AMENDMENTS TO THE DRAWINGS

REMARKS

Application No. 10/662,423
Amendment due November 7, 2006
Reply to Office Action of August 7, 2006

Docket No.: 0505-1249P

FIG. 35
~~BACKGROUND ART~~
PRIOR ART

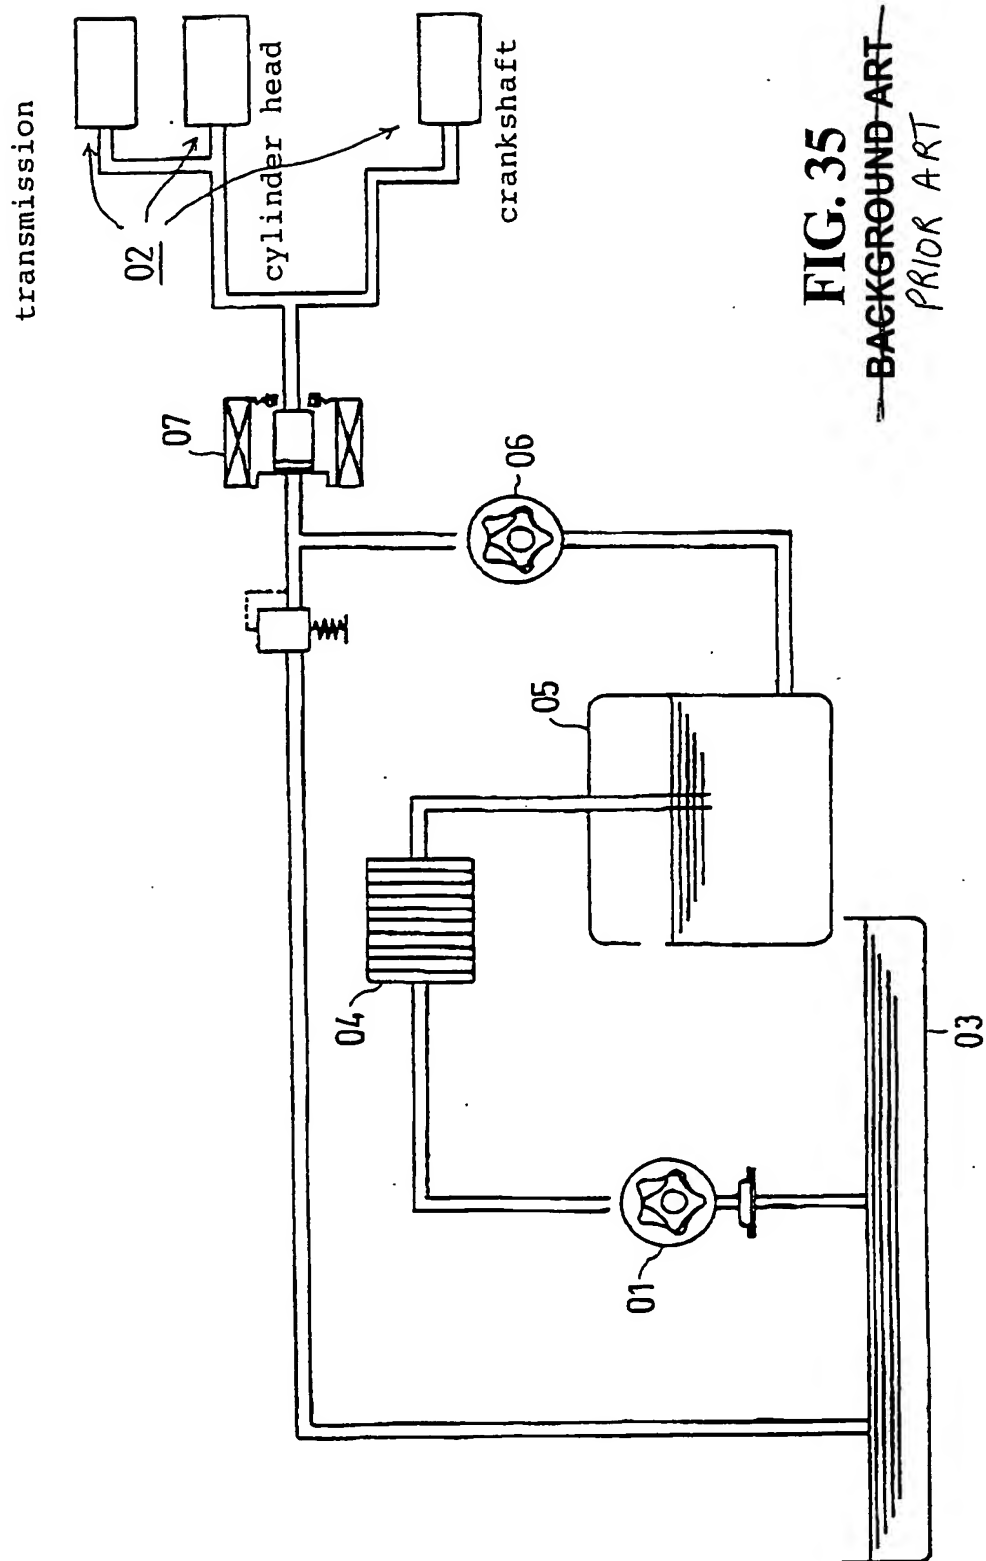
The label "Background Art" has been changed to "Prior Art" in Fig. 35.

The Examiner has objected to the drawings because the legend "Background Art" of Fig. 35 should be "Prior Art."

In order to overcome this objection, Applicants are concurrently submitting Replacement Drawing Sheets for the Examiner's approval, which address the deficiency pointed out by the Examiner. Accordingly, reconsideration and withdrawal of this objection are respectfully requested.
